# #3016656

6301 15th Ave NW **RECOMMENDATION MEETING**

LEVEL 2-4 PLAN @ NORTH PROPERTY LINE

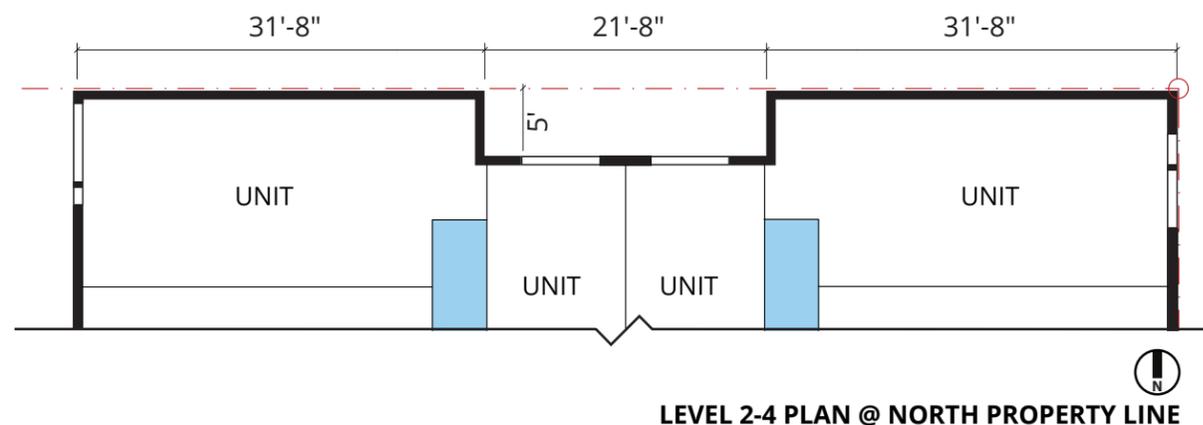
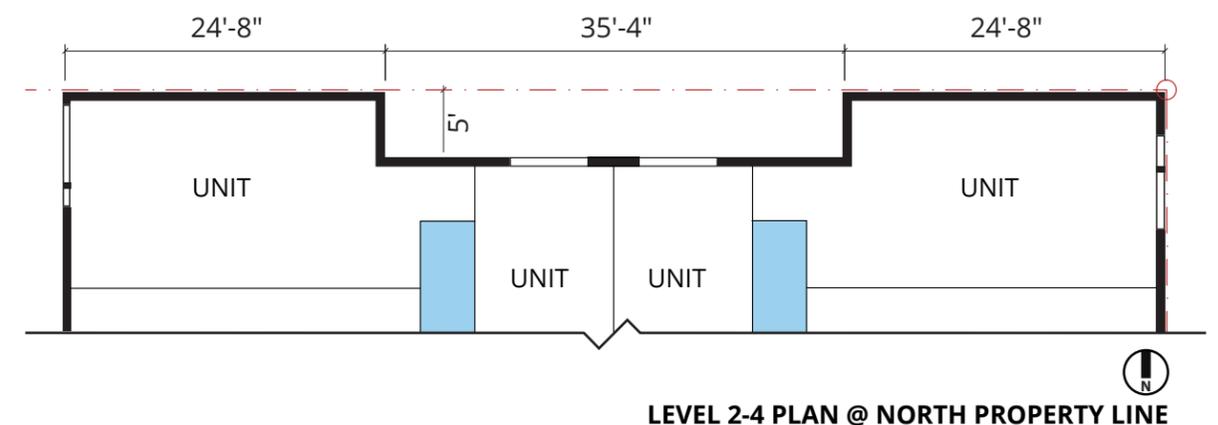
- LONGER ZERO LOT-LINE WALLS.
- GUIDANCE: "CONSIDER THE APPEARANCE OF THE BLANK NORTH WALL AS IT WILL BE HIGHLY VISIBLE FROM 15TH NW."

- ZERO LOT-LINE WALLS HAVE BEEN REDUCED WHICH EXPANDS THE RECESSED WALL AREA. RECESS FEATURES MATERIAL VARIATION AND JULIET BALCONIES. 24% DECREASE IN ZERO LOT-LINE FACADE.

## 1 WINDOW STUDY

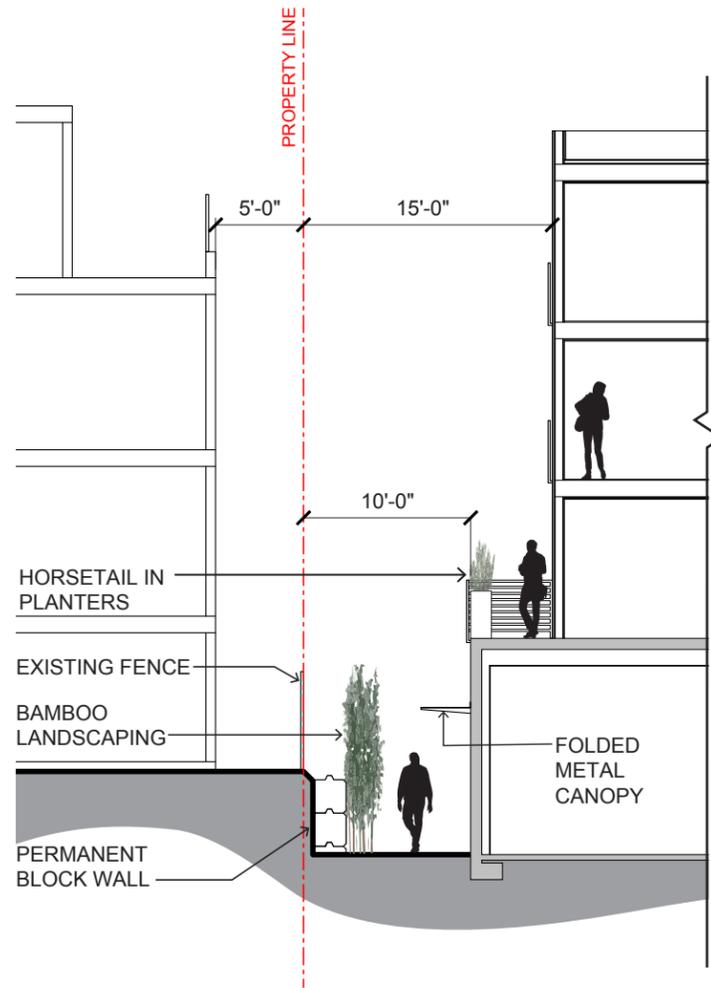
“Respect the location of the windows of the residential structure to the west when locating the development’s windows.”

Windows are arranged to provide maximum privacy to neighbors while maintaining functionality and pleasing composition of the west façade. The projects floor levels are offset from the neighboring townhouses because of the differences in grade, which results in no windows being eye-level with each other. At L1, landscaping will be provided to create increase visual privacy. The upper levels have also been set back 15' from the property line.

The window locations on the west façade have been placed in a way that is considerate to the west neighbors. See page 24 for window study diagram.
